MARK	DATE	DESCRIPTIONS	BY	CH'D	CCO#
0	03/08/10	MEP INTEGRATION	JE	FW	110

CONTRACT CHANGE ORDER NO._____
SHEET _____ OF _____

DETAILS
SCADA REMOTE TERMINAL UNIT SYSTEM
RTU #16 ASSEMBLY
NO SCALE

E-940

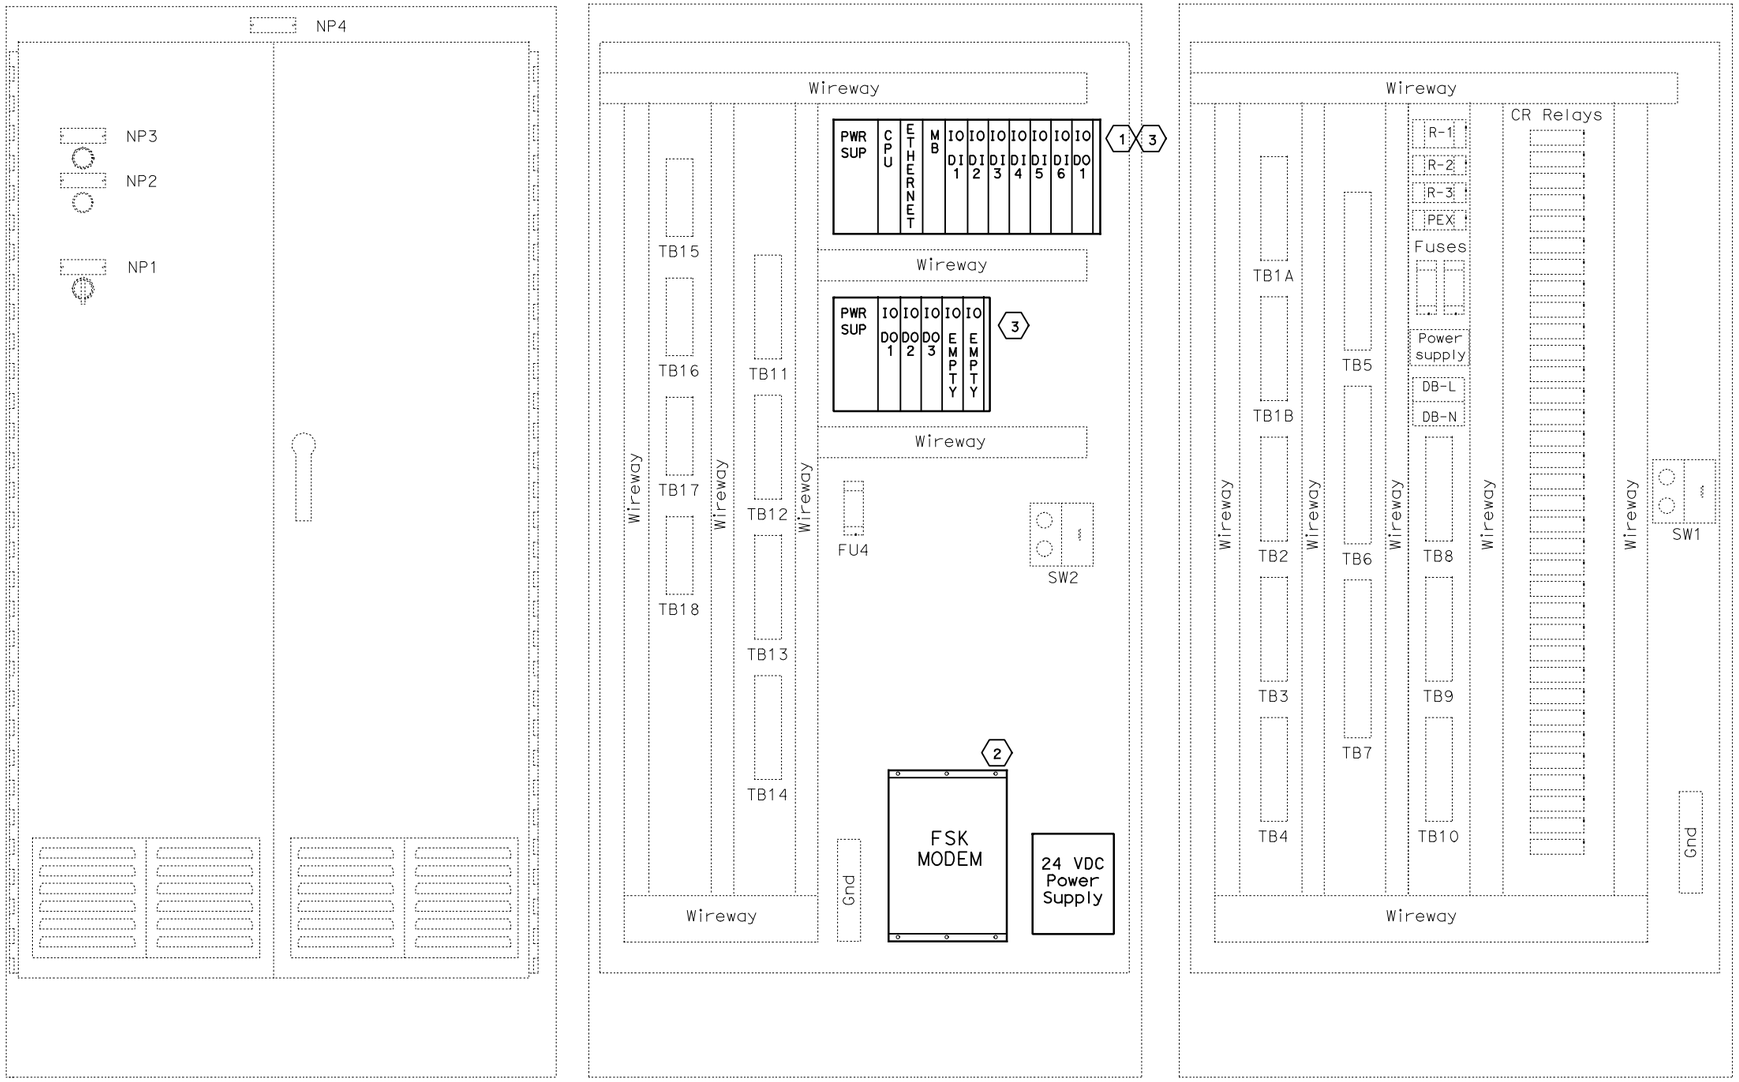
1. Contractor shall furnish and install a new GE Fanuc PAC Systems RX3i PLC in the existing RTU.
2. Contractor shall furnish and install a new Frequency Shift Key (FSK) modem and 120v (AC) to 21v-28v (DC) power supply in the existing RTU.
3. Contractor shall install the input and output cards.
